FACSIMILE TRANSMITTAL

Dave Larsen
Dunsmuir Shipyard

F/V SCANDIES ROSE
MAIN & UPPER DECK ARRANGEMENT
TO SUIT FUTURE STRUCT, w/
RAISED PILOTHOUSE

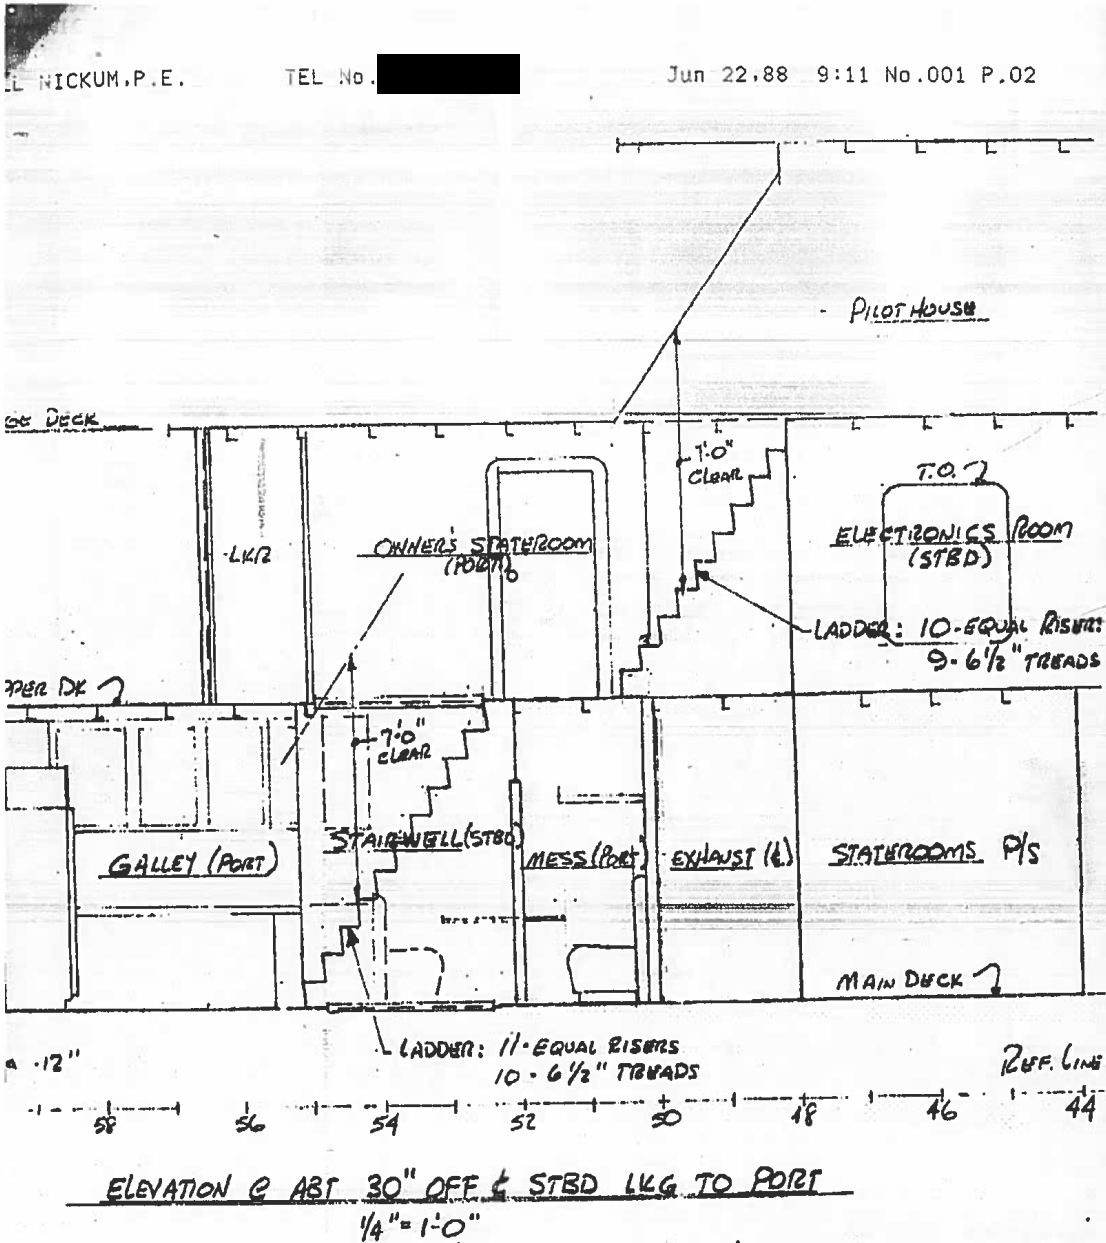
Attached sketches depict my arrangement of Galley with known equipment sizes. Leif needs to see it before you commit to it. I reworked the upper deck to suit tonnage, and specified ladder rises and runs to allow access into aft staterooms on Main deck and leave a 48" landing on upper deck.

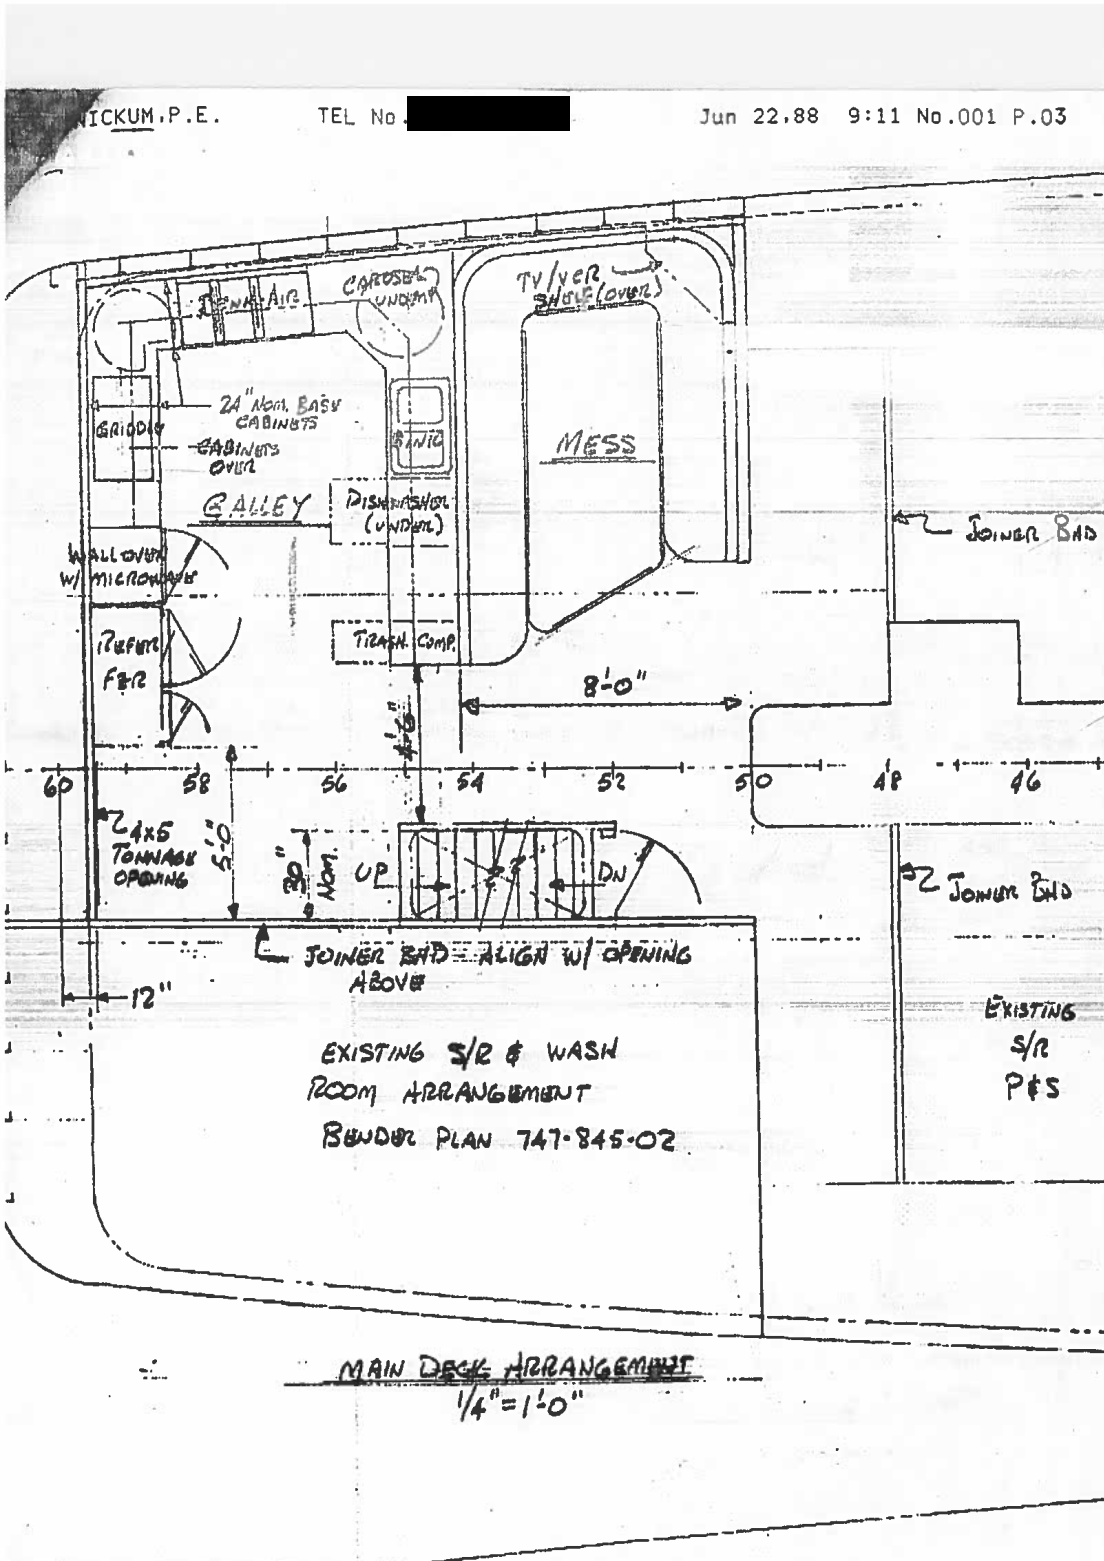
Deck cut out in upper deck should match sketch, dimensions given in upper deck view. Unfortunately, cut out on boat is too far aft, will have to relocate forward.
